Primary School, Kishoge, Lucan,  
Co. Dublin

Stage 1 Road Safety Audit

**Document Ref:** P22-066-PSW5-RP-001

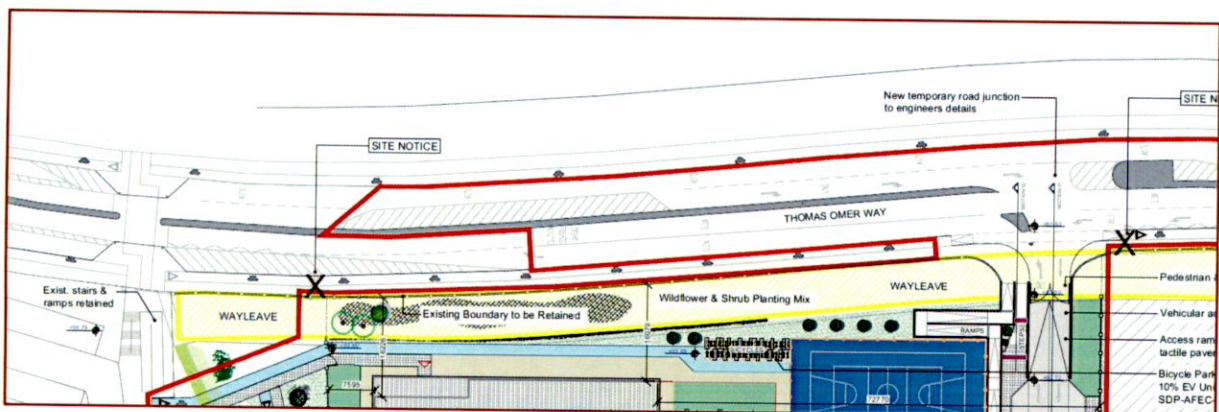
#### 3.1 Problem

*Location:* Thomas Omer Way

*Summary:* Acceleration lane may lead to drivers approaching the existing signalised pedestrian crossing to the west of the proposed new school access at inappropriate speeds.

It is proposed to provide an acceleration lane for drivers exiting the school to join the westbound traffic lane on Thomas Omer Way. There is a concern that drivers accelerating upon exiting the school in order merge with other traffic on Thomas Omer Way might fail to appreciate the proximity of the existing signalised pedestrian crossing to the west, leading to drivers approaching the crossing at inappropriate speeds and a failure to stop resulting in overshoot into the crossing and possible vehicular/pedestrian collisions.

The acceleration lane should be omitted and vehicles exiting the school access should do so directly into the westbound traffic lane.

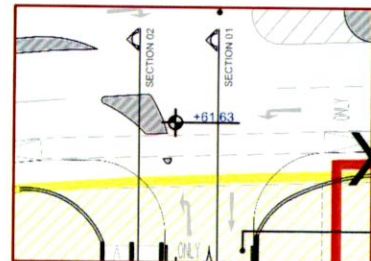
#### 3.2 Problem

*Location:* School Access Junction

*Summary:* Proposed splitter island location/layout may result in left-turning large vehicles mounting the kerb and entering the path or fail to deter unsafe right-turning manoeuvres.

The indicated location and layout of the splitter island intended to guide exiting vehicles to turn left may not safely accommodate the swept path of large left-turning exiting vehicles, potentially resulting in these vehicles mounting the kerb and encroaching onto the path presenting a hazard to non-motorised road users within the path.

In addition, the indicated layout may fail to deter some drivers from turning right when exiting from the school access, a manoeuvre which may be difficult to achieve safely due to the number of lanes approaching in each direction.

The location & layout of the proposed splitter island should be amended to ensure that the swept path of all vehicles exiting the school can be safely accommodated while ensuring right-turning exiting manoeuvres are prevented.

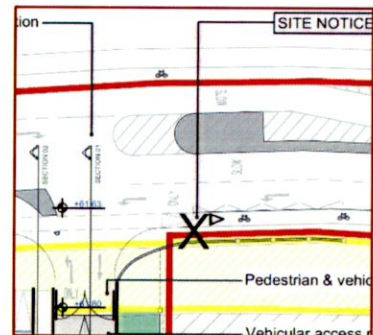
- 4.4 Zig Zag road markings are indicated at the westbound left-turn lane along Thomas Omer Way is the use of zigzag road markings are only permitted on the immediate approaches to/departure from a signalised crossing.

This assumed to be CAD error, and if so and the lines are redundant, then they should be omitted.
